State of Idaho
Department Of Environmental Quality
Technical Guidance Committee

Technical Guidance Committee Meeting

Minutes

Thursday, June 5, 2014

Figure 4-1. Cross-sectional view of a capping fill system.

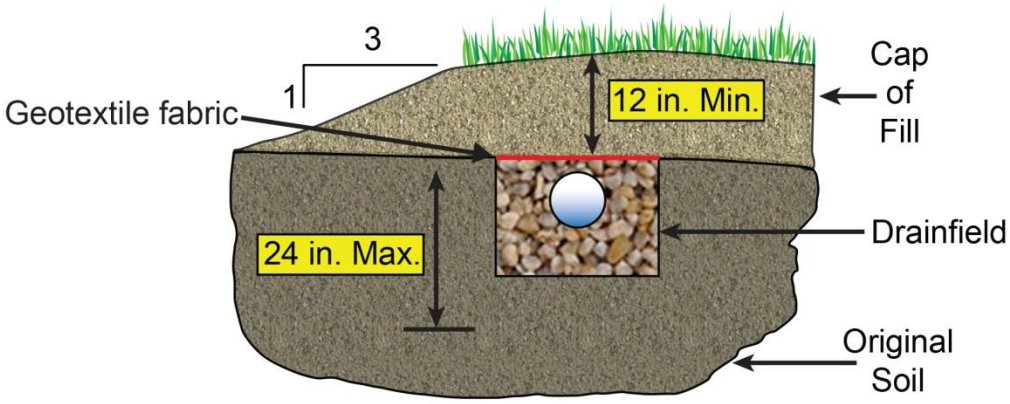
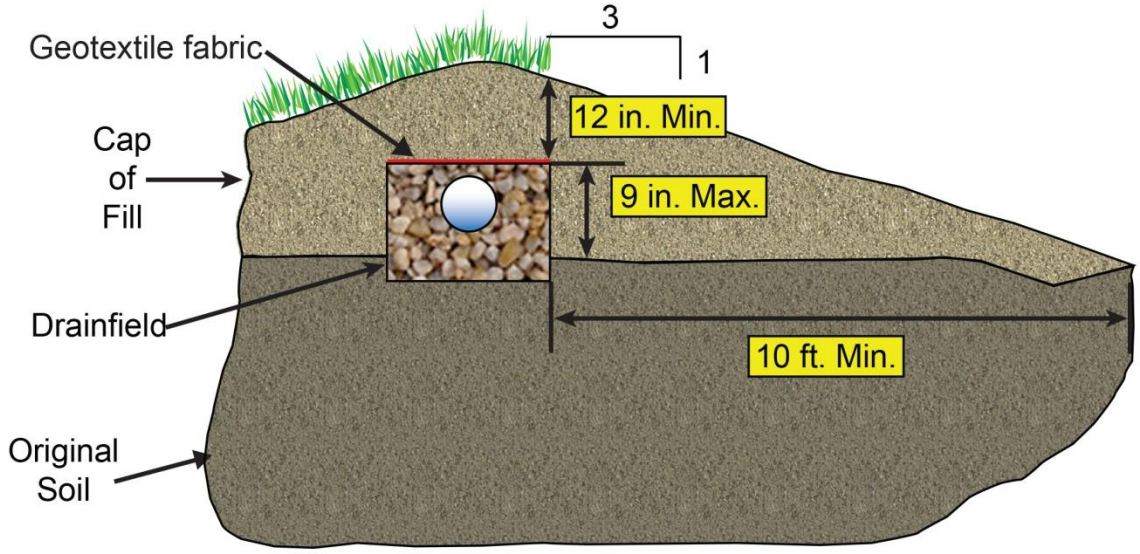
***Action Item:** Joe Canning would like a minor modification to Figure 4-1 to clarify that 12 inches of cap material is needed over the width of the drain field trench, not just at the center.

Figure 4-33. Design dimensions for use with the sand mound design checklist.

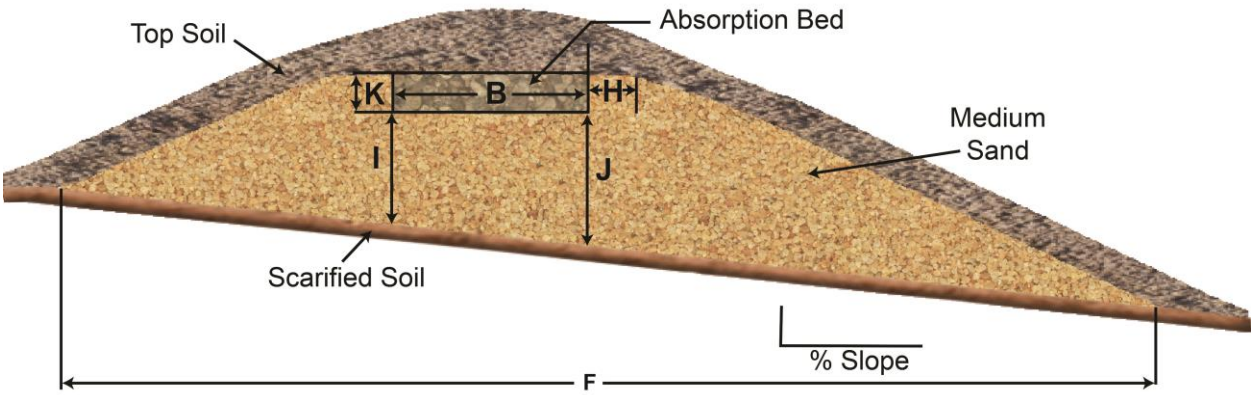
1. Move H in Figure 4-33 to a more visible location on the figure.
2. Adjust the design checklist and add back in items 7 and 8.
3. Look into suggested ripping/scarification widths and depths.
4. Move the 15 foot description in Figure 4-34 so it is not split by the arrow and make this dimension a minimum.
